HISTORIC AND DESIGN REVIEW COMMISSION

December 20, 2017

HDRC CASE NO: 2017-630
ADDRESS: 429 DEVINE ST
LEGAL DESCRIPTION: NCB 2957 BLK 1 LOT 8
ZONING: R-5, HS
CITY COUNCIL DIST.: 1
DISTRICT: Lavaca Historic District
LANDMARK: House
APPLICANT: Richard & Susan Theis
OWNER: Richard & Susan Theis
TYPE OF WORK: Construction of a single family residential structure
APPLICATION RECEIVED: December 01, 2017
60-DAY REVIEW: January 30, 2018
REQUEST:

DRAWING TITLE
AUXILIARY UNIT
FLOOR PLAN &
ELEVATIONS
SHEET 9

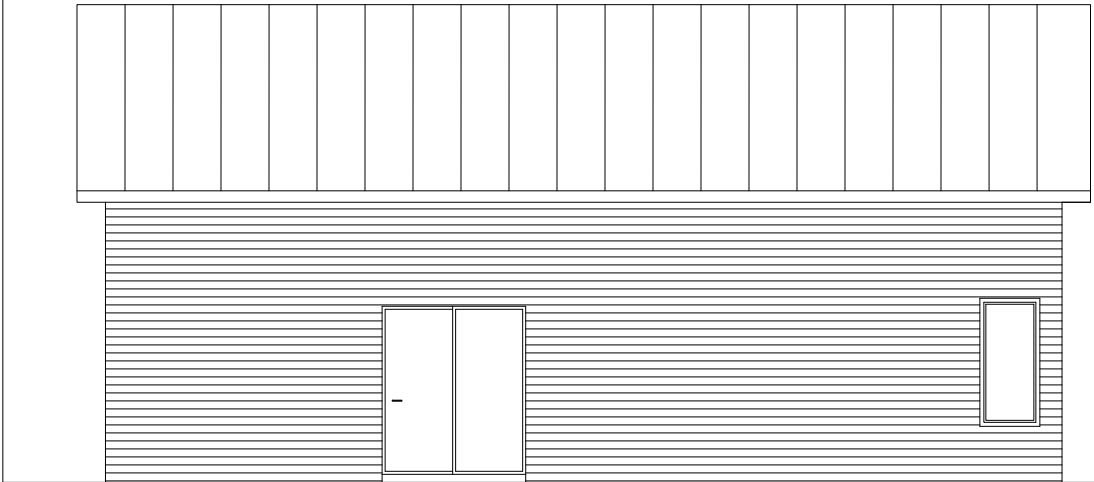
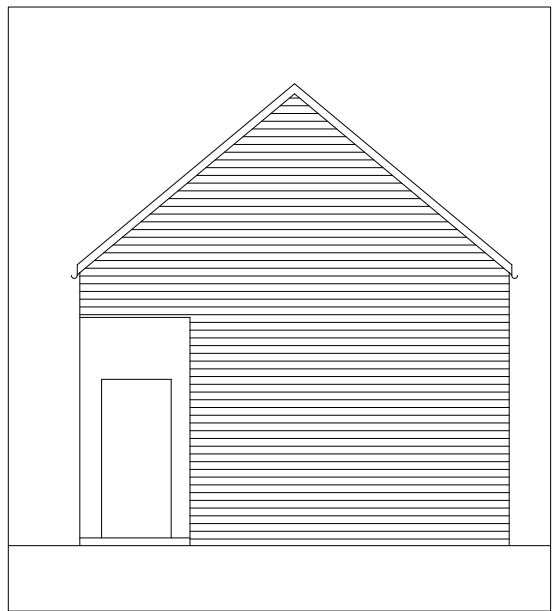
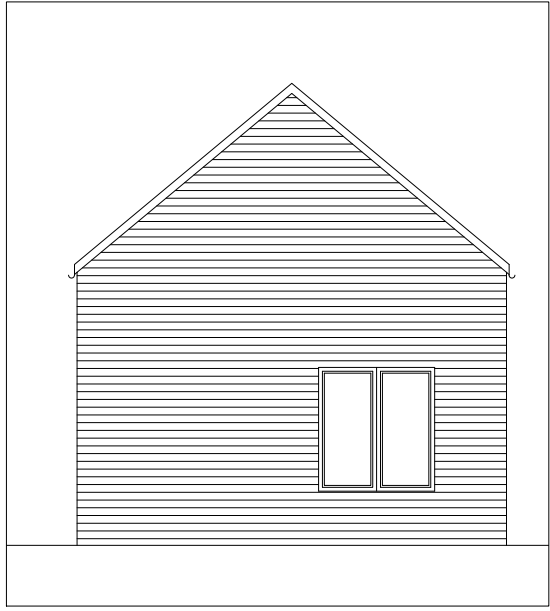
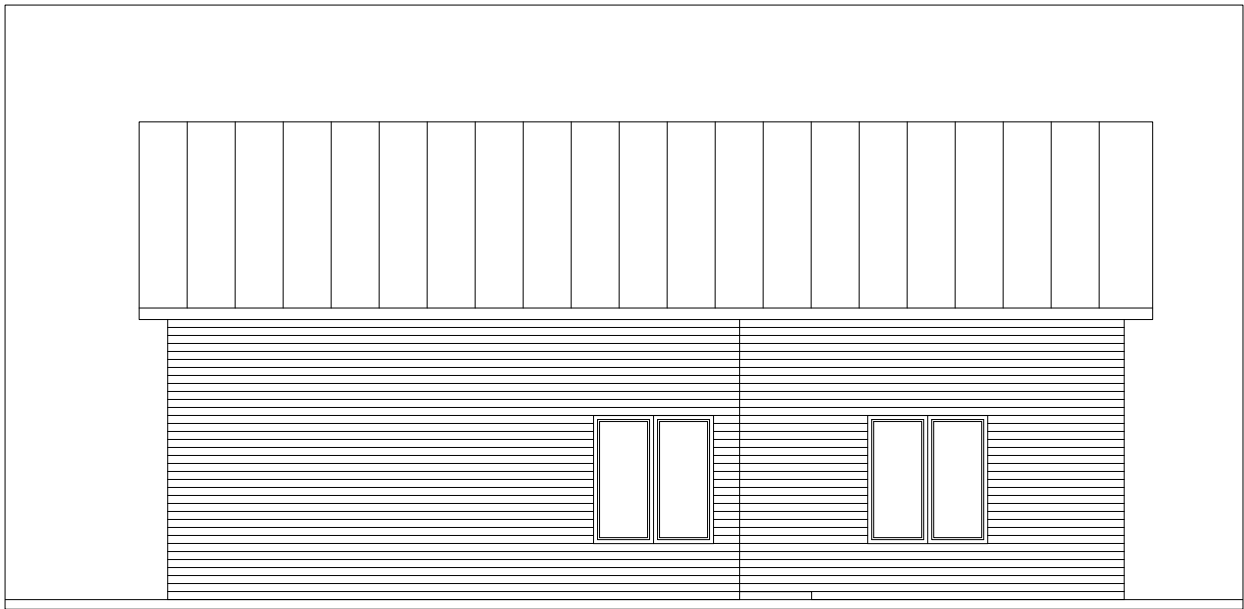
- o. **ACCESSORY STRUCTURE** – At the rear of the lot, the applicant has proposed to construct an accessory structure to feature a total size of approximately 600 square feet. Generally, staff finds the location, massing and proposed materials appropriate; however, the accessory structure should feature materials specifications consistent with those noted in findings j and k.

- xi. That the proposed accessory structure features material detailing consistent with that of the primary structure as noted in finding o.
- xii. That the proposed sidewalk align with the front door and should feature a width consistent with those found historically in the district; typically three to four feet in width as noted in finding q.
